PCN No. JW040326

PCN Notice for Multiple Touch Panel Products

Due to the sudden discontinuation announcement from the current ITO film provider, FCL will need to approve a new ITO film for the products listed below. We apologize for any inconvenience this sudden notice might cause you.

透過率/Transmittance

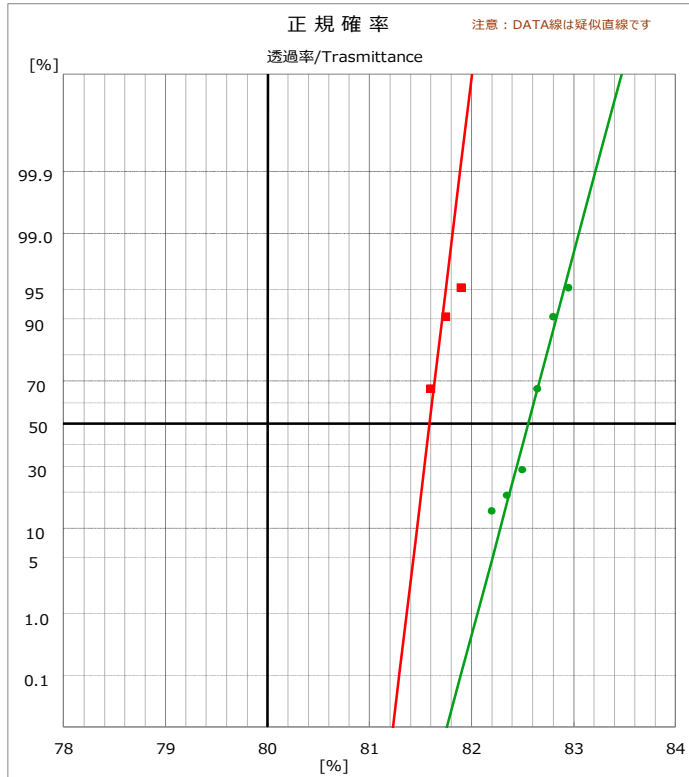
確認項目 Item	Spec	測定結果/Result		判定 judge	Data page	
		現行仕様品 Conventional product	変更仕様品 Modified product			
光学特性 Optical	透過率 Transmittance	80% typ.	81.5~81.8 %	82.1~82.9 %	OK	2
	ヘイズ Haze	6% typ.	5.9~6.1 %	5.8~6.0 %	OK	2

Spec : 80% typ
(80% Min.で定義)

4. 結論 Conclusion
 仕様書記載値通りの実力を有すると判断できる。
 It can be judged to have the competence value as per the specifications.

ヘイズ/Haze

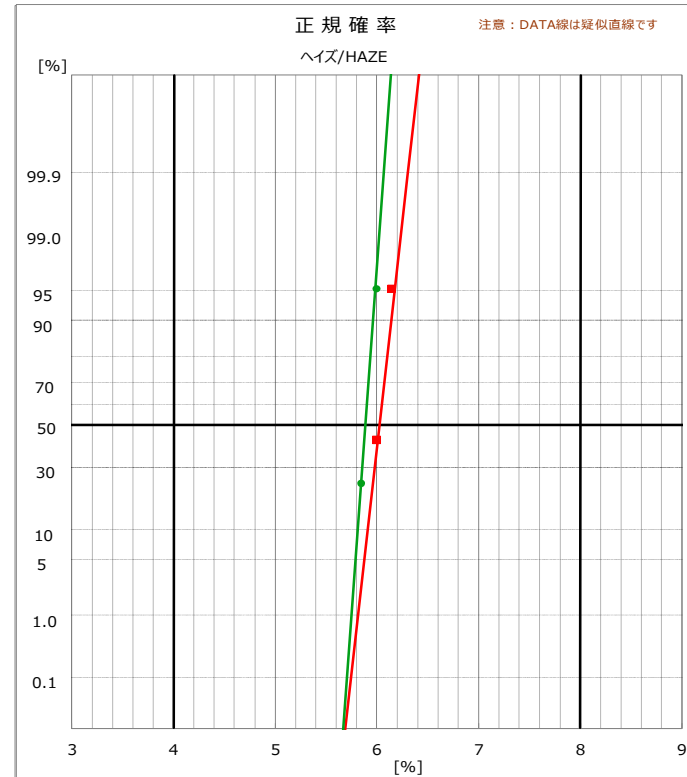
Spec : 6% typ
(±2% で定義)

ITEM(Object)	エッジ摺動試験	Date
	Area edge sliding test

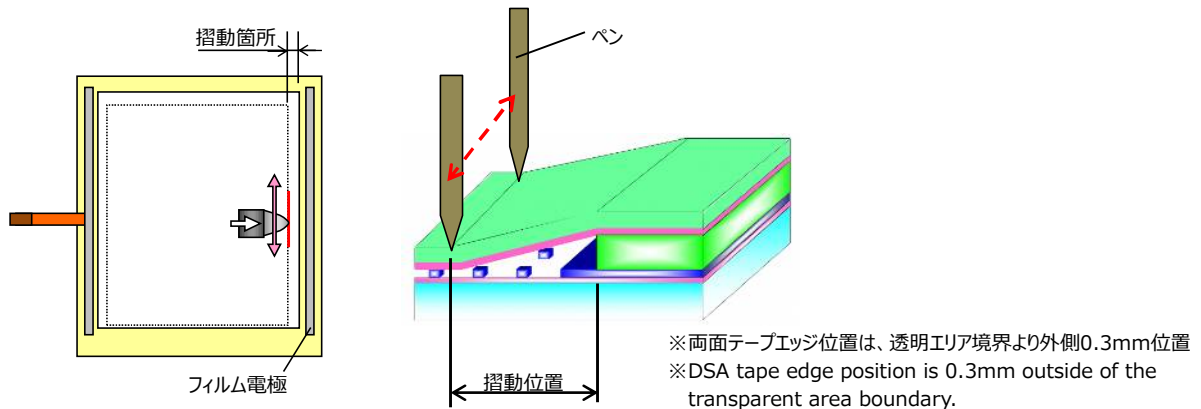
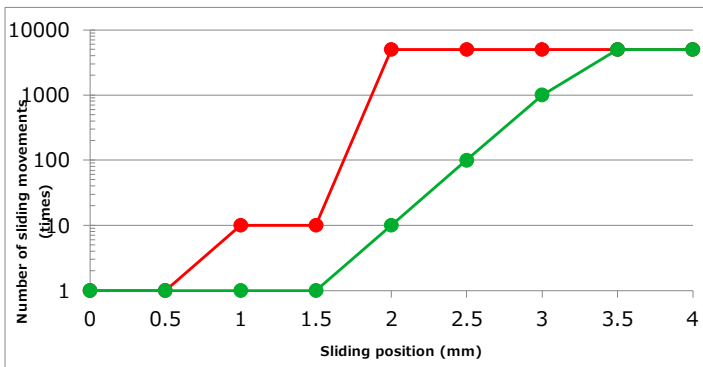
現行仕様品は両面テープより内側2.0mm以上の摺動位置で悪化が見られなくなるのに対し、変更仕様品は3.0~3.5mm以上の実力となる。

While the current product will not deteriorate at sliding positions of 2.0 mm or more inside the double-sided tape, the new specification product will have the ability to show no deterioration at sliding positions of 3.0 to 3.5 mm or more.

- 結論 : 実使用環境におけるケース際のゴミの除去や清掃等を想定した試験となります。
 Conclusion : As shown in the above results, the durability of the modified product is slightly lower than that of the conventional product when subjected to irregular operations such as removing debris from the edge of the guaranteed operation area. Therefore, please consider design modification such as case modification if necessary. if you use a protective sheet or other film on the surface of our touch panel (film side), the performance will be better than above, so please evaluate as necessary. Although this test is outside of the warranty, it is presented here as reference data because of the possible effects described above.

【当社図番 P/No.】

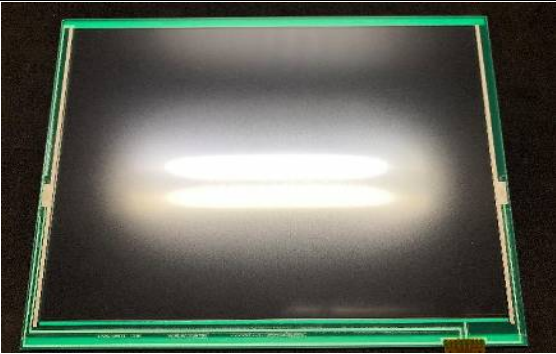
Due to this change, our drawing number will be updated. Therefore, instead of revising the existing specification, we will prepare and issue a new specification under a new drawing number.

変更仕様は現行図番の末尾に"-K"を付与。

The modified specification will be identified by appending "-K" to the end of the current part number.
